RAMONA-ALESSANDRO ELEMENTARY SCHOOL MODERNIZATION
670 RAMONA AVENUE
SAN BERNARDINO, CA 92411

NO.	REVISIONS	DATE	NO.	REVISIONS	DATE
1	DSA ADDENDUM NO. 1	2/10/10			
4	ADDENDUM NO. 4	3/11/10

REMODELED FLOOR PLAN 'B' WING

DESIGNED MRoth	PROJECT NO. 3137117
DRAWN MMinamide	SCALE 1/8"=1'-0"
CHECKED QC	DRAWING NO. 1 AB2.1
DATE 19 MAR 2004

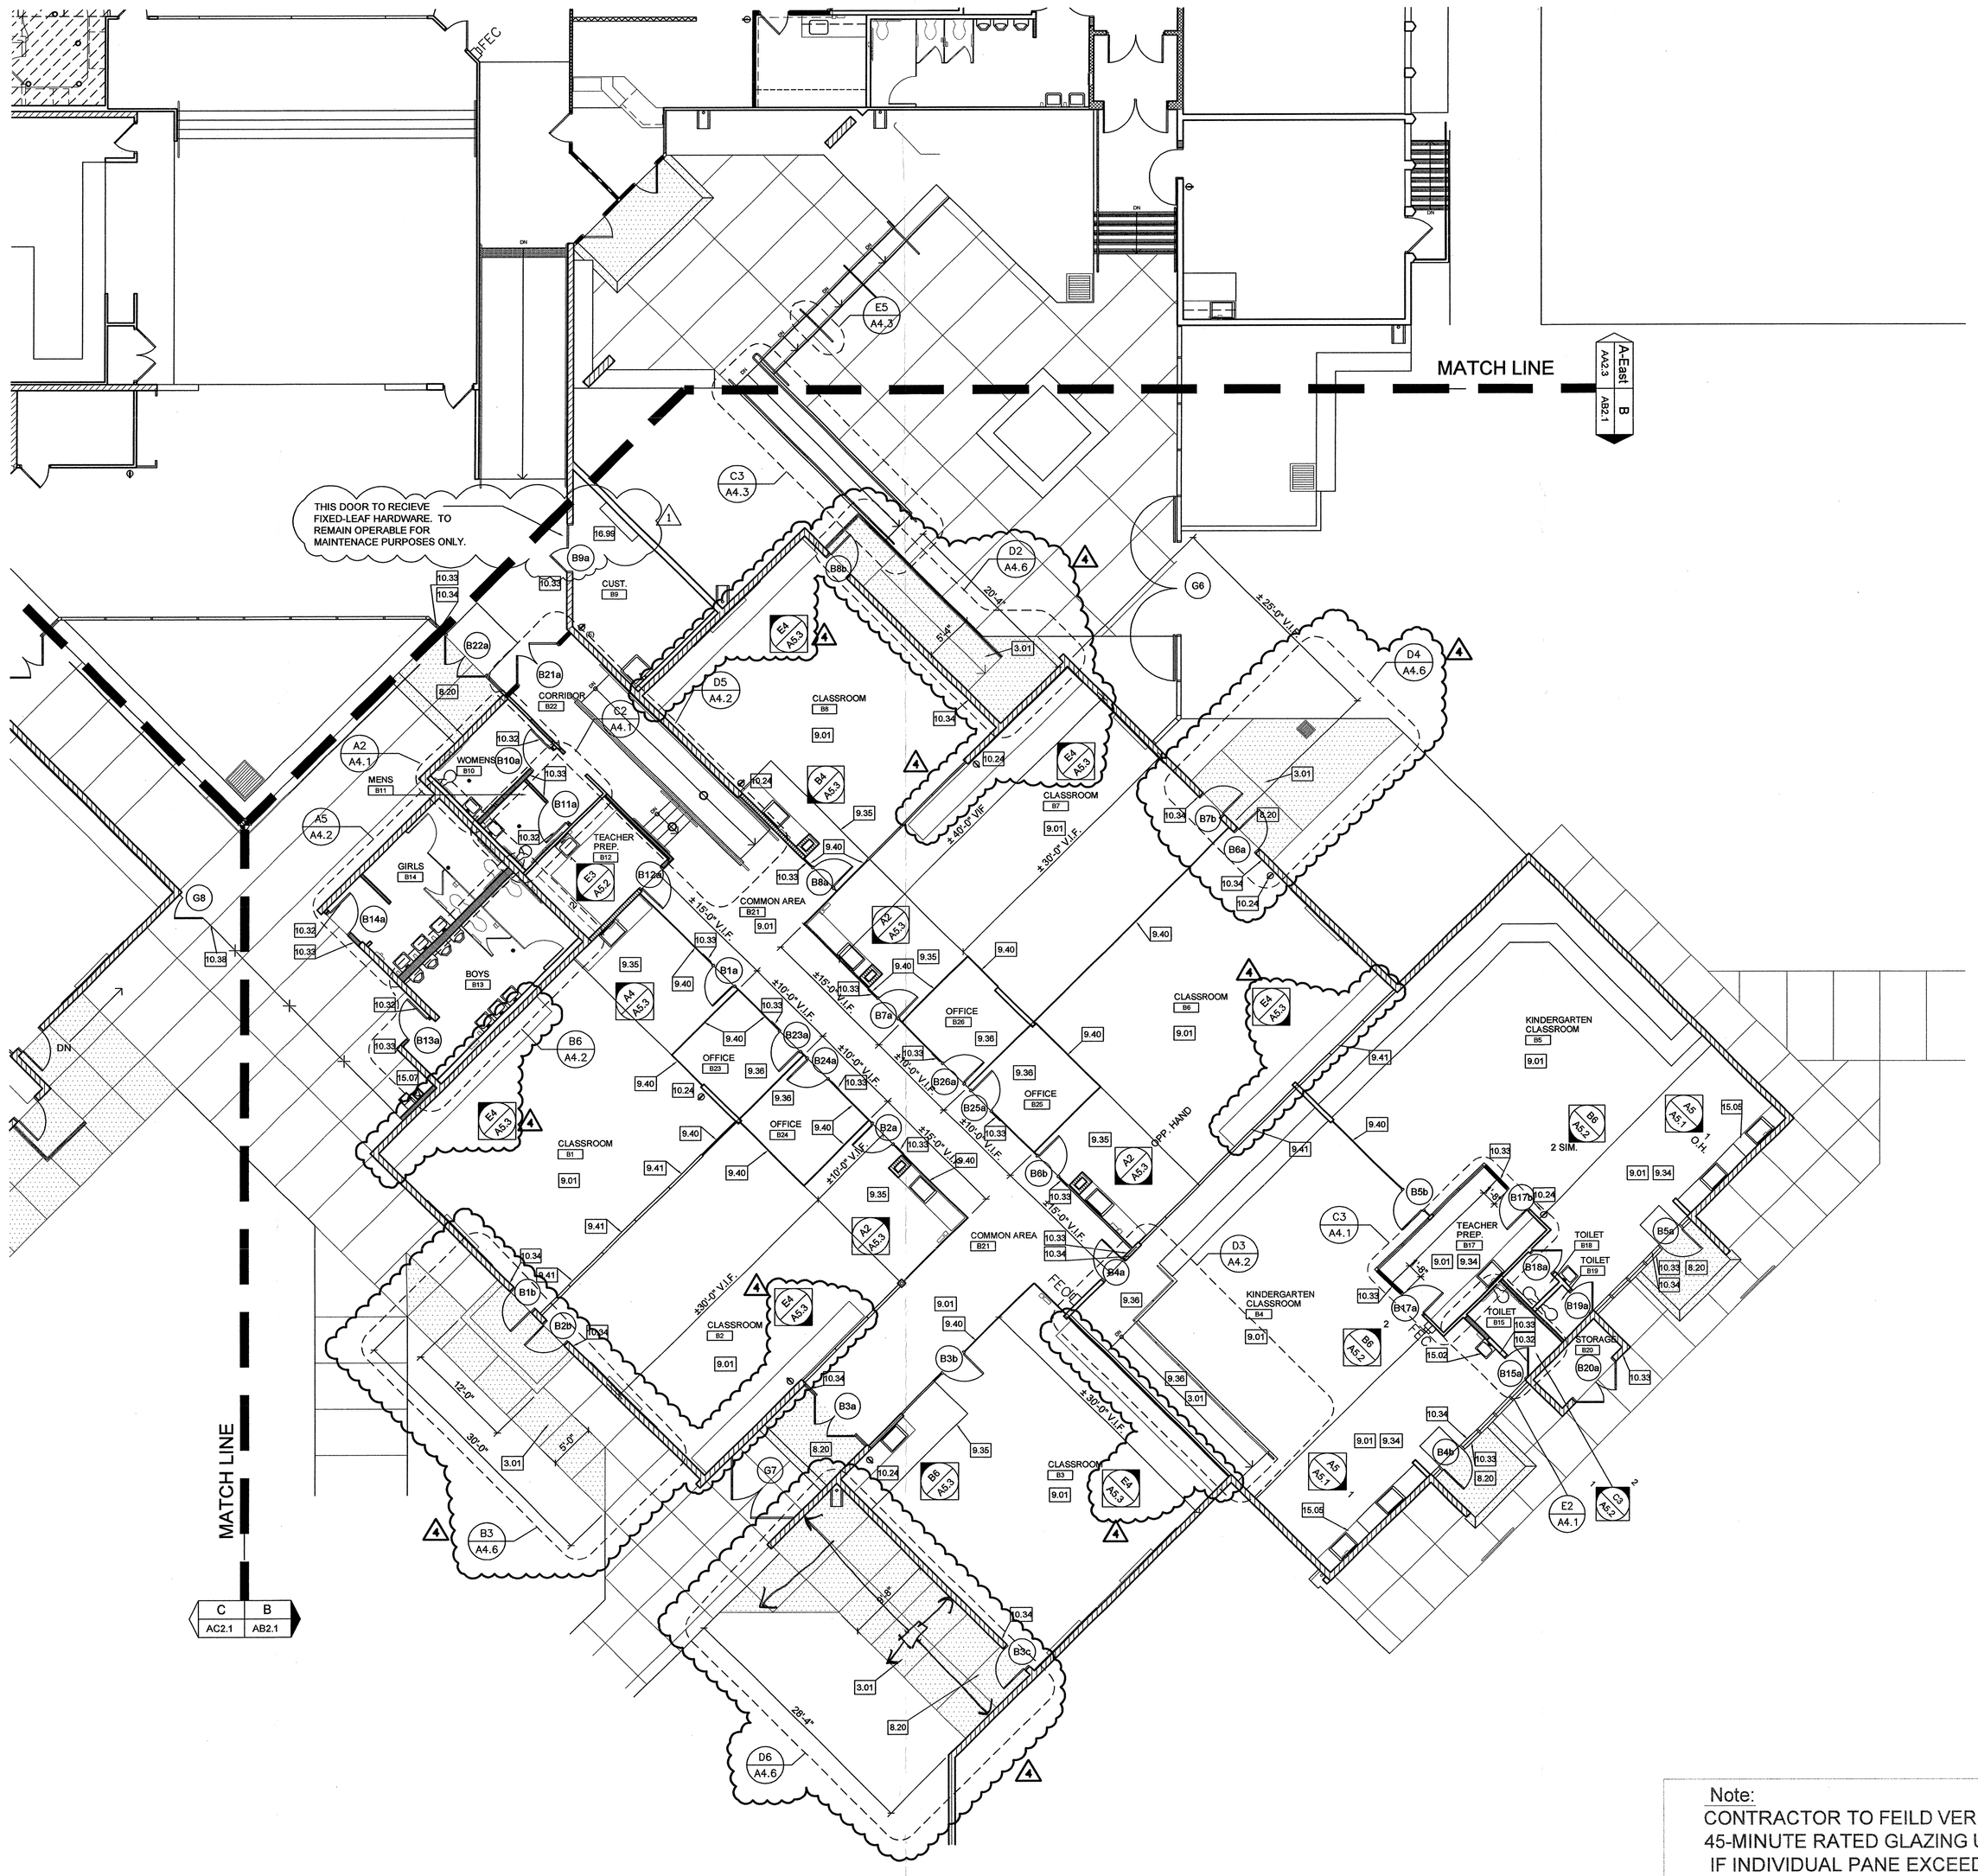
Note:
CONTRACTOR TO FEILD VERIFY
45-MINUTE RATED GLAZING UNIT SIZES.
IF INDIVIDUAL PANE EXCEEDS 1296 SQ. IN.
CONTRACTOR IS REQUIRED TO PROVIDE A
"FIRELITE" 45 MIN. RATED
GLAZING UNIT.
